UNITED STATES
DEPARTMENT OF THE INTERIOR
BUREAU OF LAND MANAGEMENTFORM APPROVED
OMB NO. 1004-0137
Expires: January 31, 2018**SUNDRY NOTICES AND REPORTS ON WELLS**
*Do not use this form for proposals to drill or to re-enter an abandoned well. Use form 3160-3 (APD) for such proposals.*Lease Serial No.
29395A

☒ Oil Well ☐ Gas Well ☐ Other8. Well Name and No.
TONY FEDERAL 32. Name of Operator
APACHE CORPORATIONContact: EMILY FOLLIS
E-Mail: Emily.Follis@apachecorp.com9. API Well No.
30-015-304703a. Address
303 VETERANS AIRPARK LANE SUITE 1000
MIDLAND, TX 797053b. Phone No. (include area code)
Ph: 432-818-180110. Field and Pool or Exploratory Area
[96831]CEDAR LAKE; GLOR

Tony Federal #3
API # 30-015-30470
L-18-17S-31E

Tony Federal 3
30-015-30470
Apache Coportaion
Conditions of Approval

Apache Corp.
Proposed

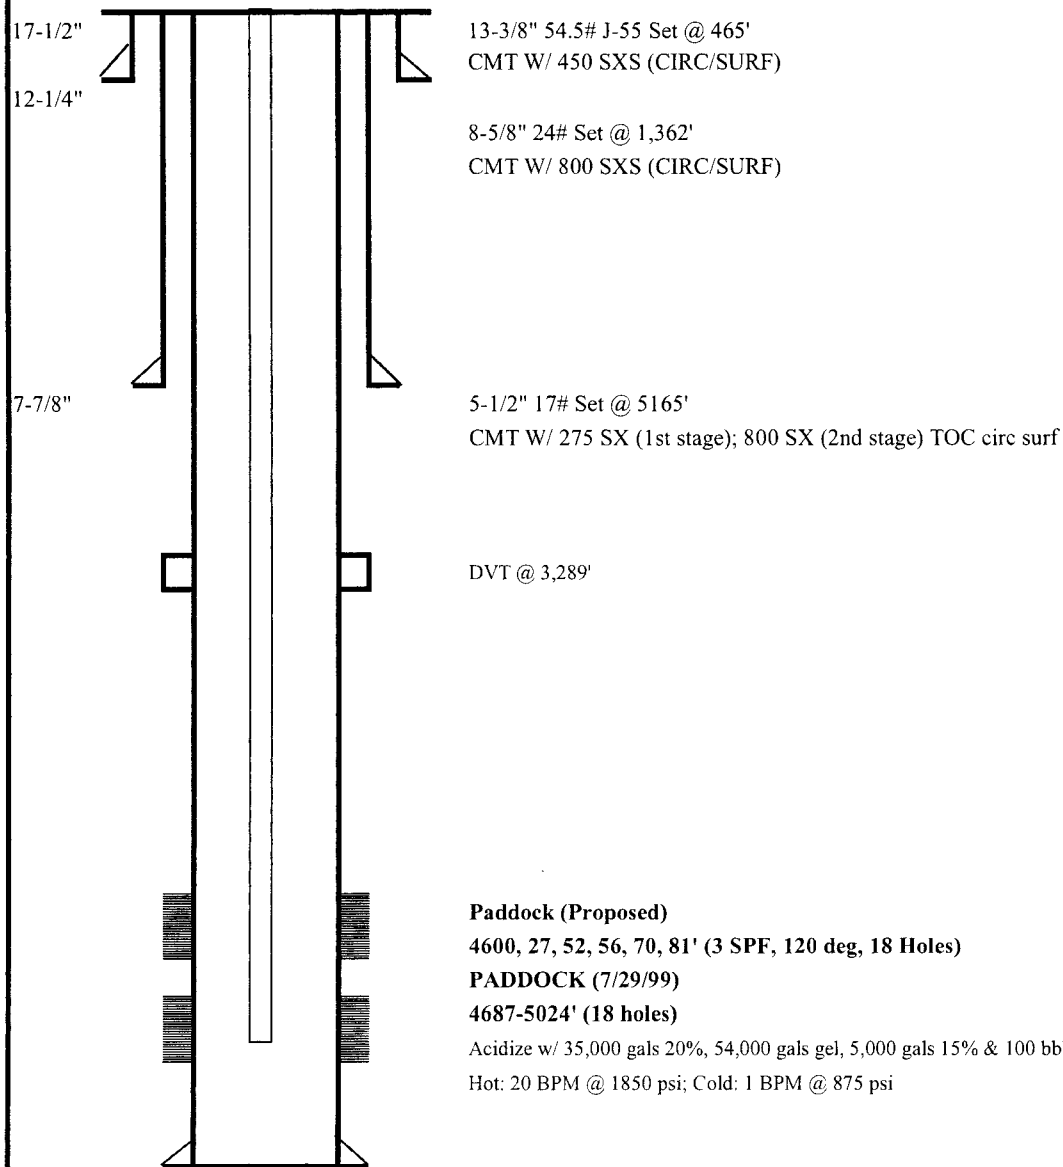
1. Must conduct a casing integrity test before perforating and fracturing. Submit results to BLM. The CIT is to be performed on the production casing to max treating pressure. Notify BLM if test fails.
2. Before casing or a liner is added or replaced, prior BLM approval of the design is required. Use notice of intent Form 3160-5.
3. Surface disturbance beyond the originally approved pad must have prior approval.
4. Closed loop system required.
5. All waste (i.e. drilling fluids, trash, salts, chemicals, sewage, gray water, etc.) created as a result of work over operations shall be safely contained and disposed of properly at a waste disposal facility. No waste material or fluid shall be disposed of on the well location or surrounding area. Porto-johns and trash containers will be on-location during fracturing operations or any other crew-intensive operations.

6. Operator to have H2S monitoring equipment on location.
7. A minimum of a 2000 (2M) BOP to be used. All blowout preventer (BOP) and related equipment (BOPE) shall comply with reasonable well control requirements. A two ram system with a blind ram and a pipe ram designed for the size of the work string shall be adequate. Tapered work strings will require an additional pipe ram. The manifold shall comply with Onshore Oil and Gas Order #2 Attachment I (2M Diagrams of Choke Manifold Equipment). The accumulator system shall have an immediately available power source to close the rams and retain 200 psi above pre-charge. The pre-charge test shall follow requirements in Onshore Order #2.

8. **Subsequent sundry required detailing work done, a C-102 form, and completion report for the new formations. Operator to include well bore schematic of current well condition when work is complete.**
